Addenda No. 1

SUBJECT: OR 99: Walker Ave. To I-5 (Ashland) Resurfacing
Rogue Valley Highway
Jackson County
Paving and Signing Project
(Bids to be opened and read November 9, 2006)

The following changes are made to the Project Bid Booklet:

OREGON DEPARTMENT OF TRANSPORTATION ROADWAY ENGINEERING SECTION	
OR 99: WALKER AVE. TO I-5 (ASHLAND) ROGUE VALLEY HIGHWAY JACKSON COUNTY	
Design Team Leader - James Burford Designed By - Nelly Salazar-Lazaro Drafted By - Dan Roberts	
TYPICAL SECTIONS	SHEET NO. 2A

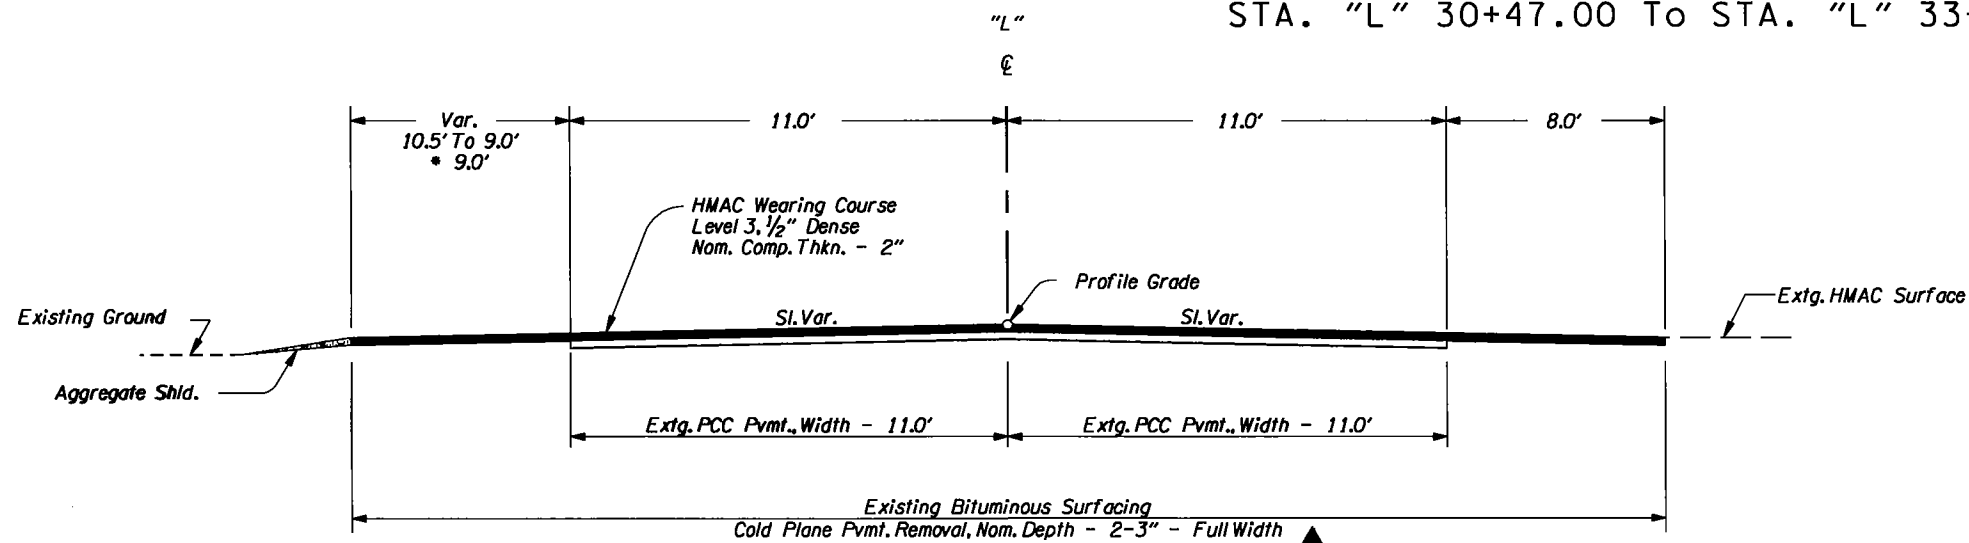
Revised 10-30-06, Changed Removal Depth to 2-3"

OREGON DEPARTMENT OF TRANSPORTATION ROADWAY ENGINEERING SECTION	
OR 99: WALKER AVE. TO I-5 (ASHLAND) ROGUE VALLEY HIGHWAY JACKSON COUNTY	
Design Team Leader - James Burford Designed By - Nelly Salazar-Lazaro Drafted By - Dan Roberts	
TYPICAL SECTIONS	SHEET NO. 2A-2

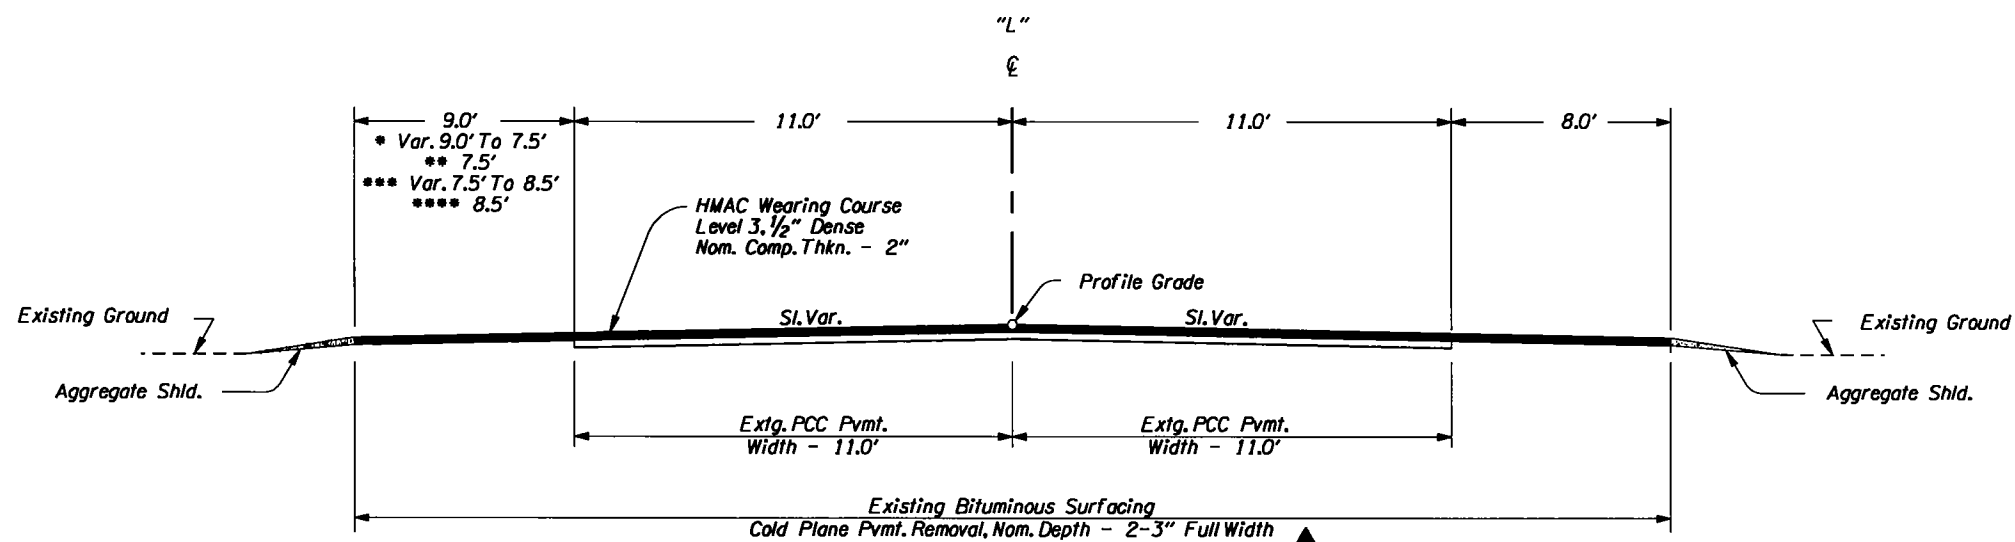
① Revised 10-30-06, Changed Removal Depth to 2-3"

SHEET NO.
2A-3

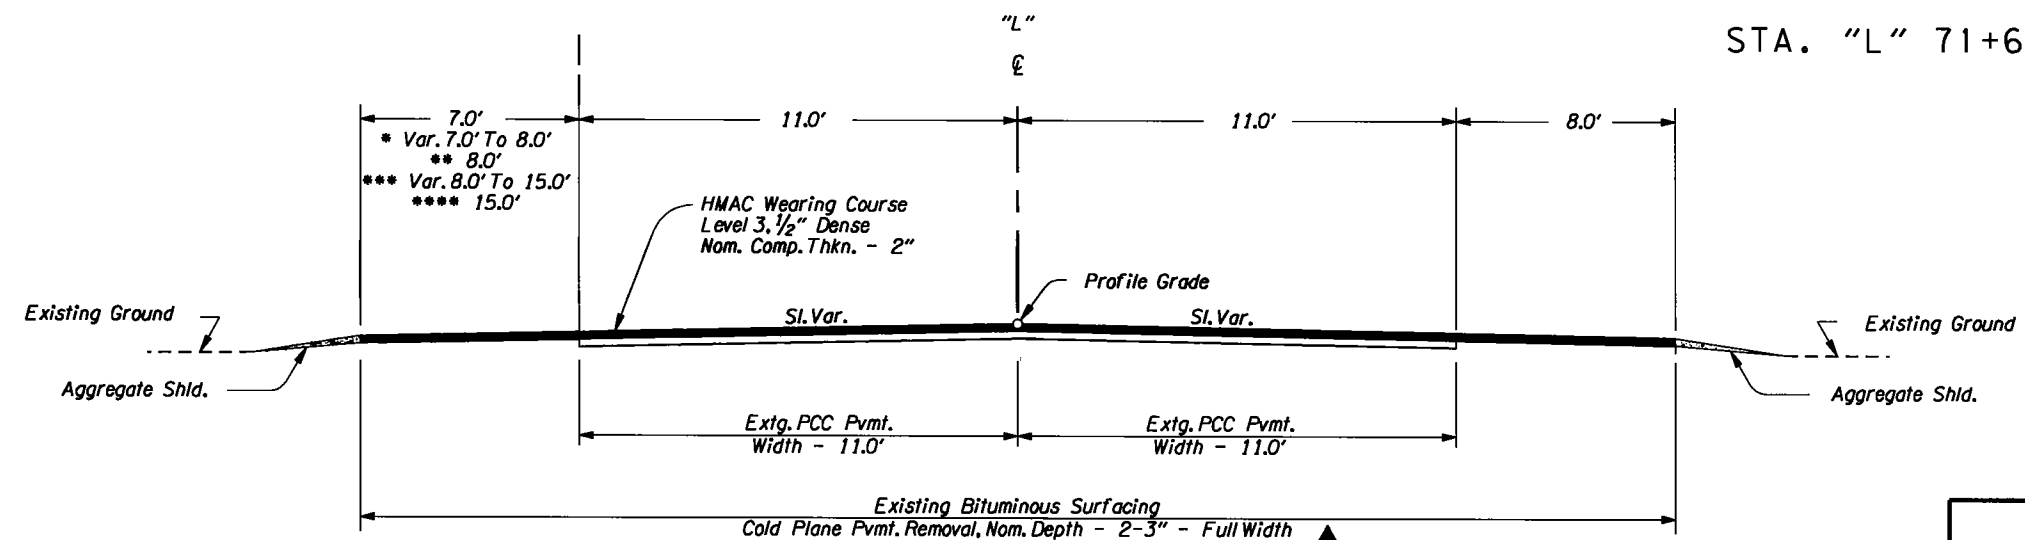
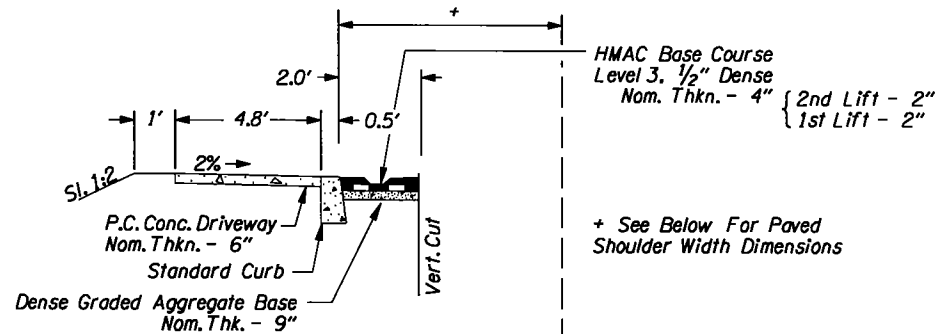
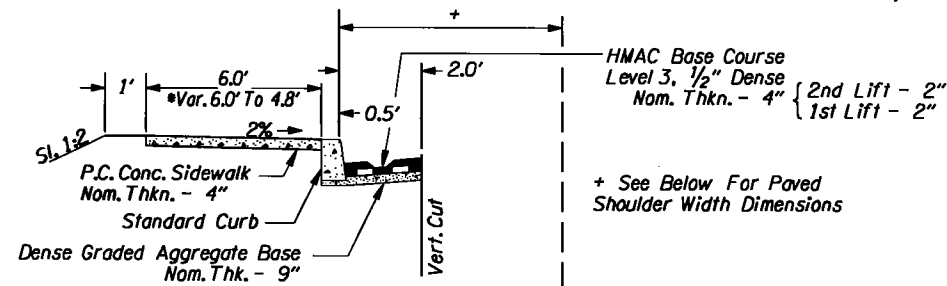
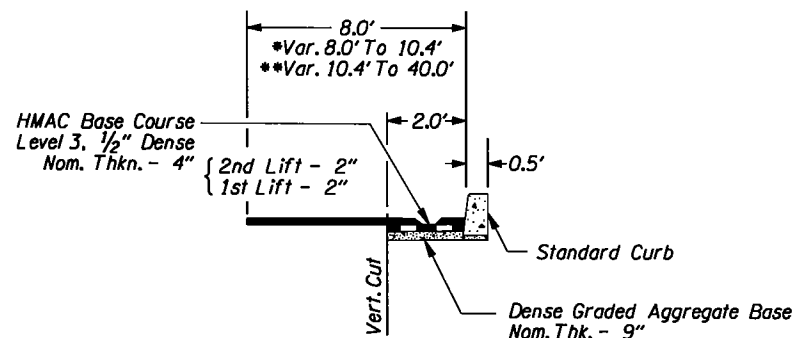
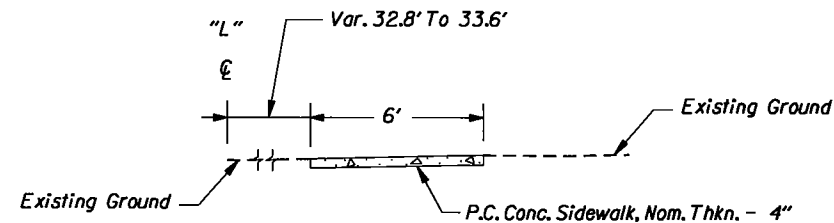
Revised 10-30-06
 Changed Removal Depth to 2-3"
